Department of Buildings of The City of New York.

Plan No. 202

APPLICATION FOR ERECTION OF BRICK BUILDINGS.

Amendment to Application No. 263 N. B. B, 1902.

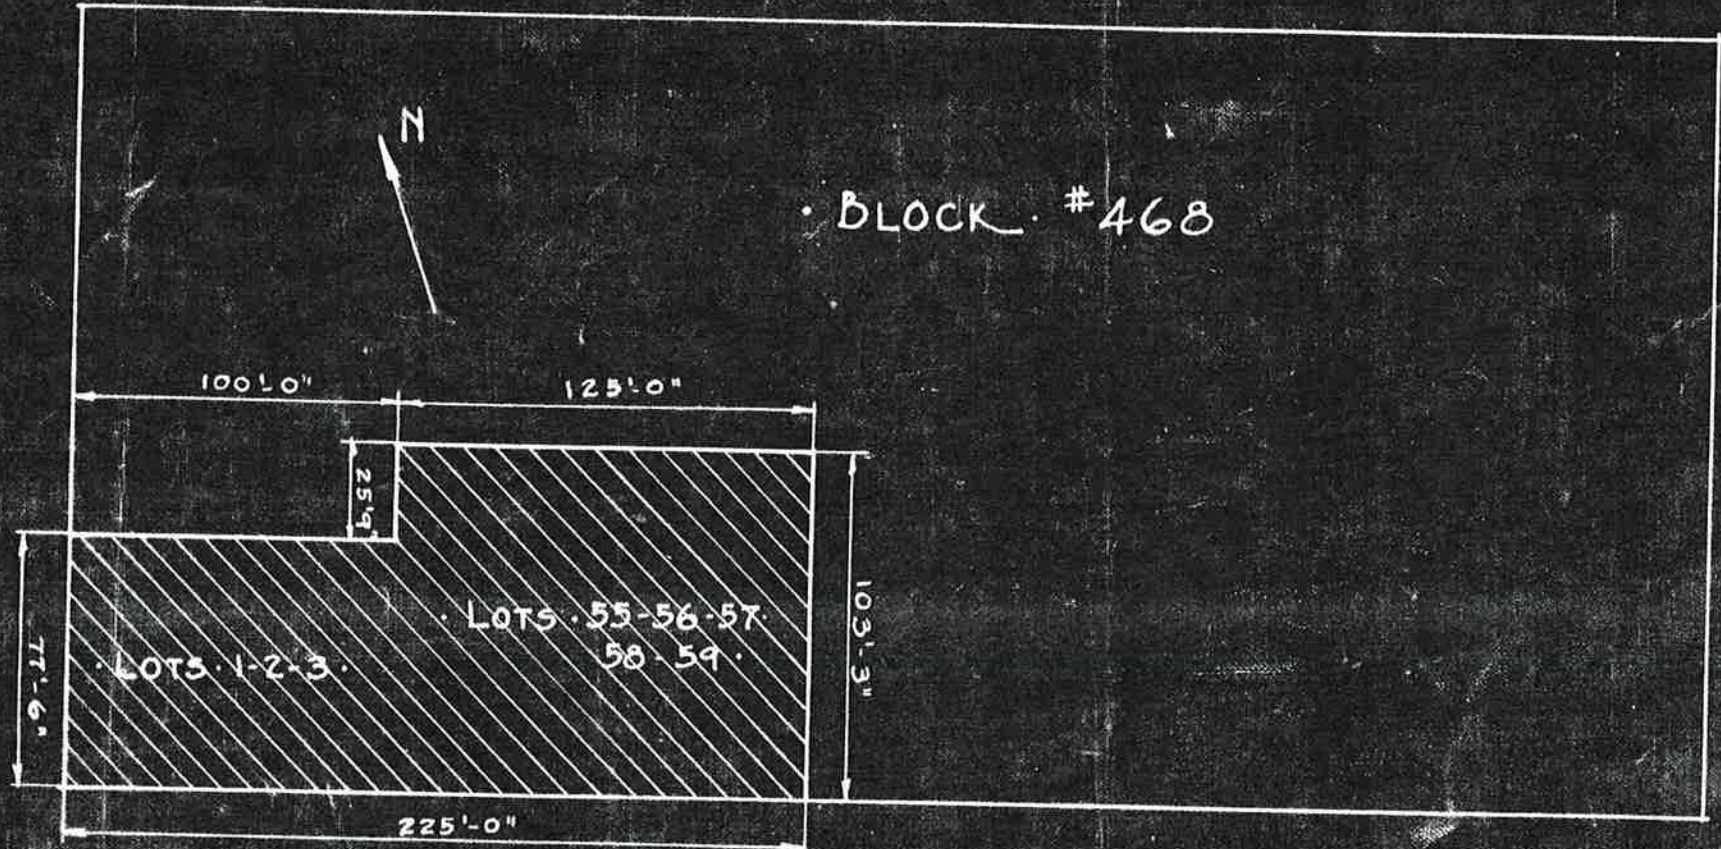
It is proposed to install new toilet accommodations for 15 females, employees on the 4th floor of No. 205-209 East 12th Street, also sub-
dividing corridor partitions, all as shown on drawing No. 30 filed herewith.

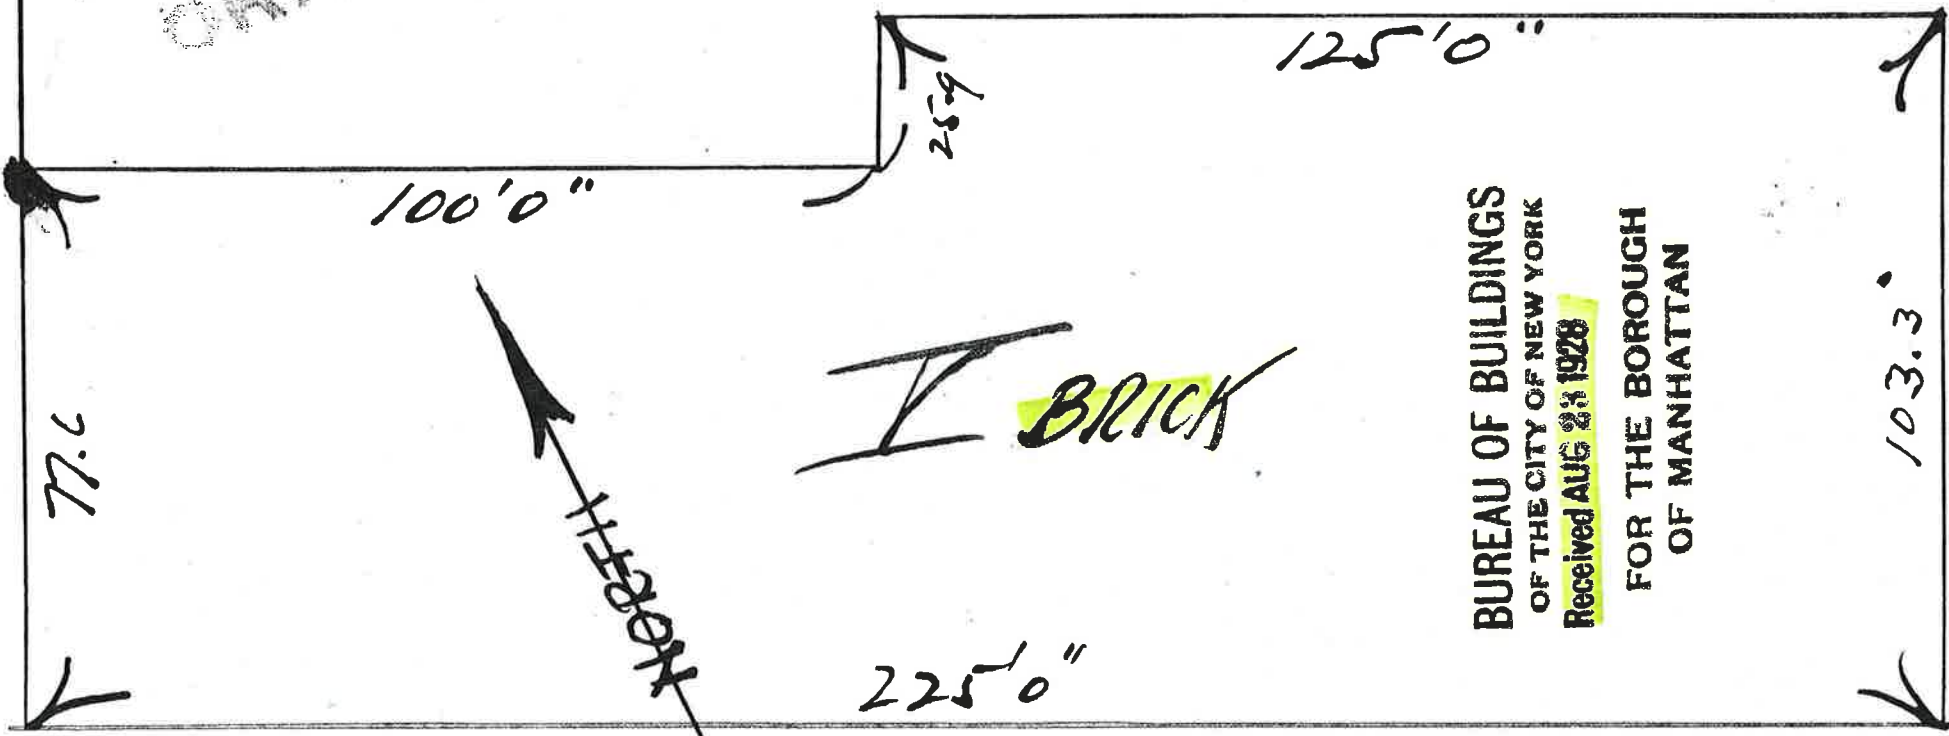
(8) STATE GENERALLY IN WHAT MANNER THE BUILDING WILL BE ALTERED: It is proposed to install driveway inside of building 1st story on 12th Street front and take out brick pier between two windows and cut down to sidewalk, install steel beams and stone cor arches, also install steel girders to support brickwork above driveway opening at front, enclose driveway with L & T iron filled in with 6" T.C. block and cover ceiling above driveway with wire lath and 3/4" p.c. and all as shown on plan.

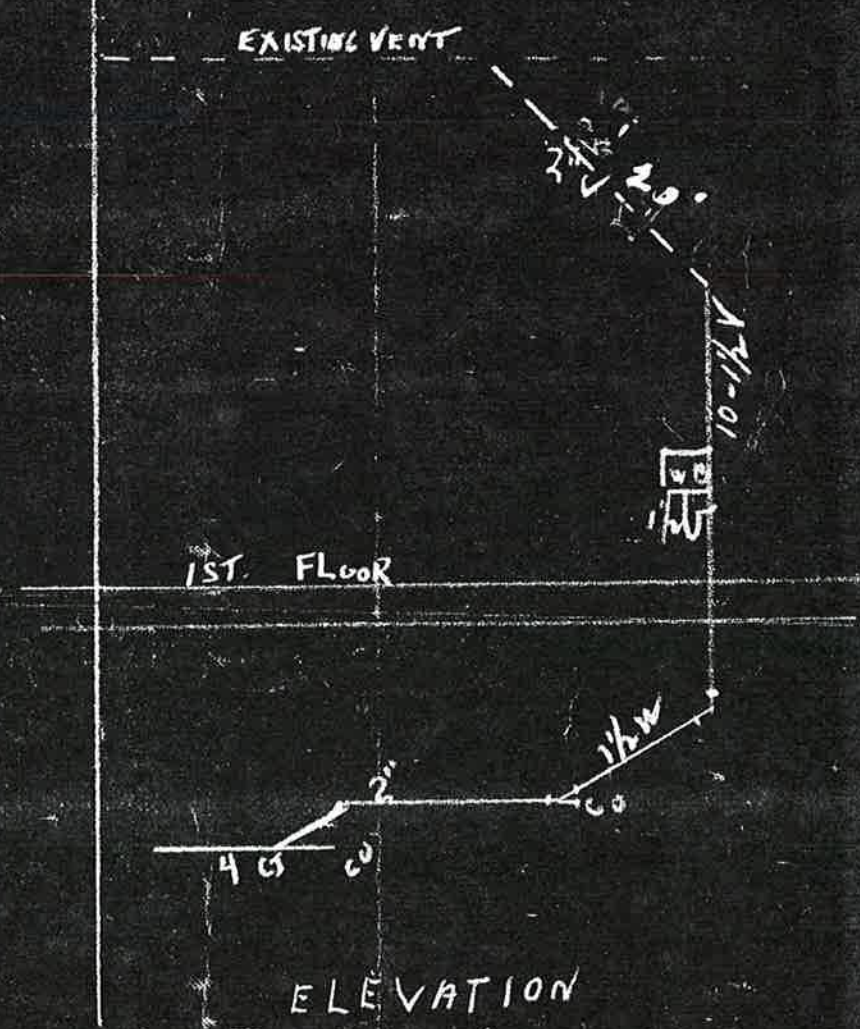
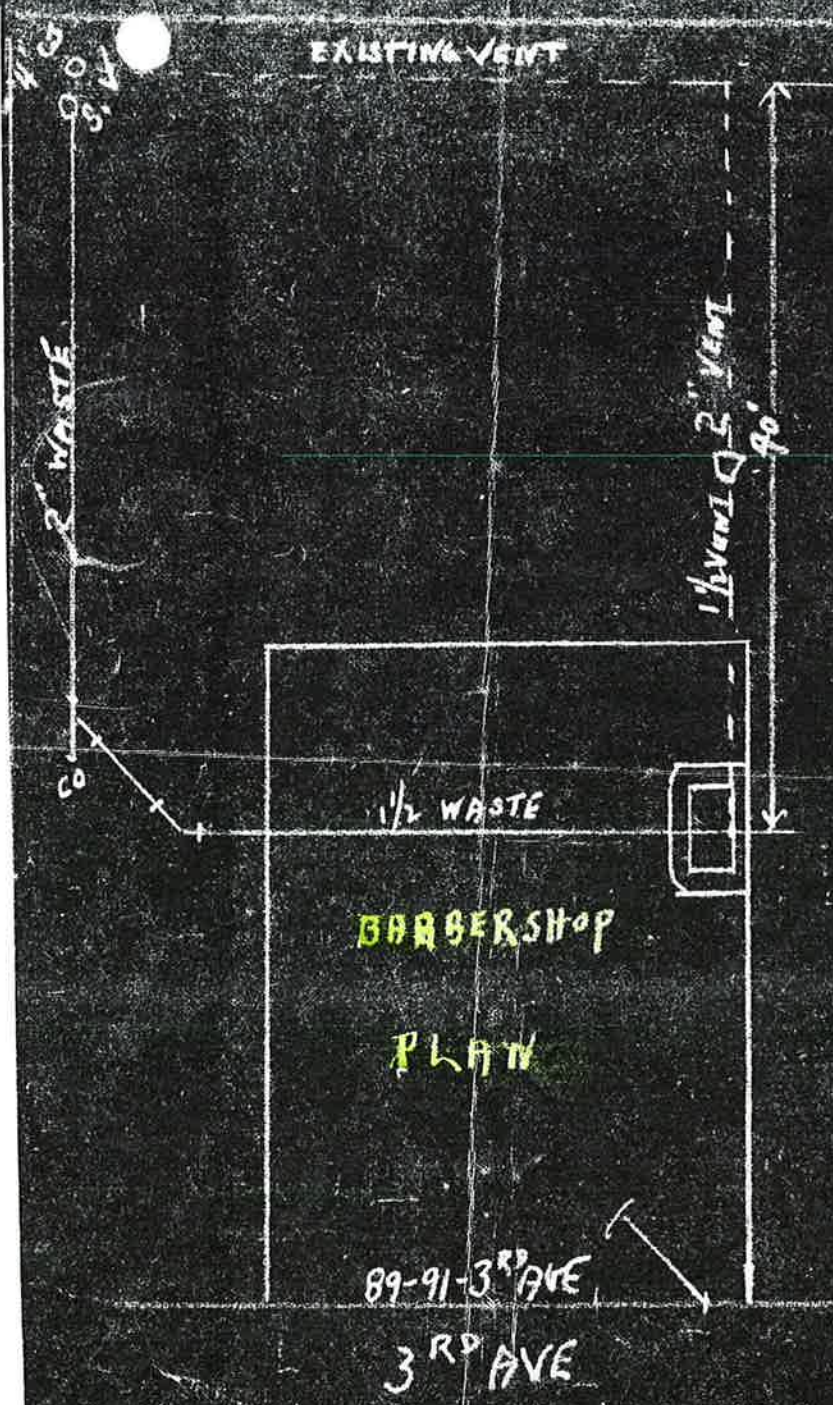
1. Permitt will be obtained from Highway Department before proceeding with work beyond the building line.
2. Sidewalk-375# total load,
 Reinforcement-Steel area .0666-4"x16" mesh-#7-#10 wires.
 Driveway-195# total load,
 Reinforcement-Steel area .0432-4"x16" mesh-#9-#11 wires.
3. Changed to Beth G 8" 32.5#
4. Chng beams and girders where marked B.G. 18"x86# over driveway opening, 10" is in place of 8" IB over sidewalk.

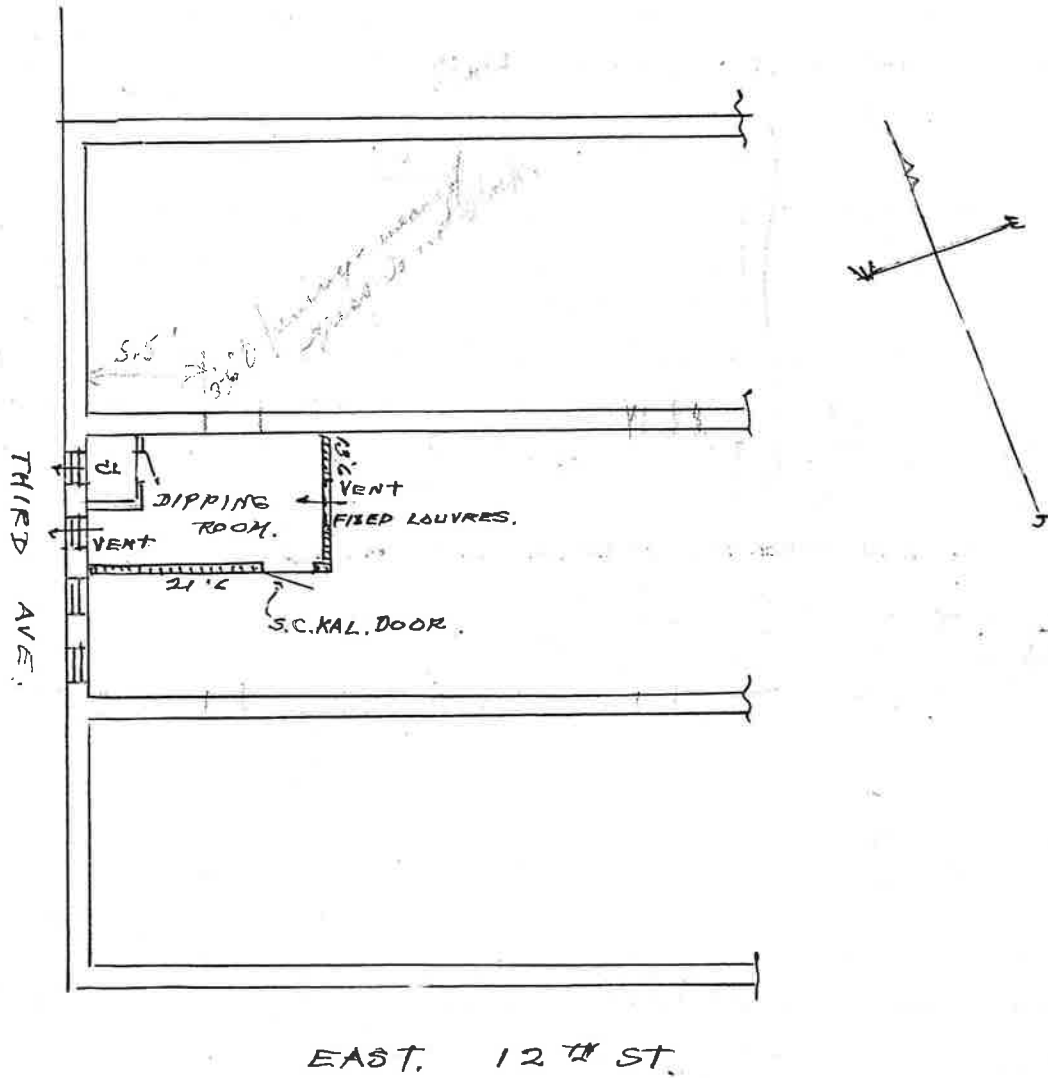
State proposed work in detail: **In the North East corner of the center section of the third floor, construct an enclosure partition forming a room to be used for dipping of the products that are made. This partition will be of Gypsum blocks, plastered on both sides from floor to ceiling, the ceiling will be covered with half inch plaster board, joints to be pointed up. There will be a fixed louvered ventilator in the end partition, self closing metal covered one hour test door at the entrance to room, jamb and trim metal covered. In the window will be placed necessary exhaust fan, to the outer air. See plan on other side.**
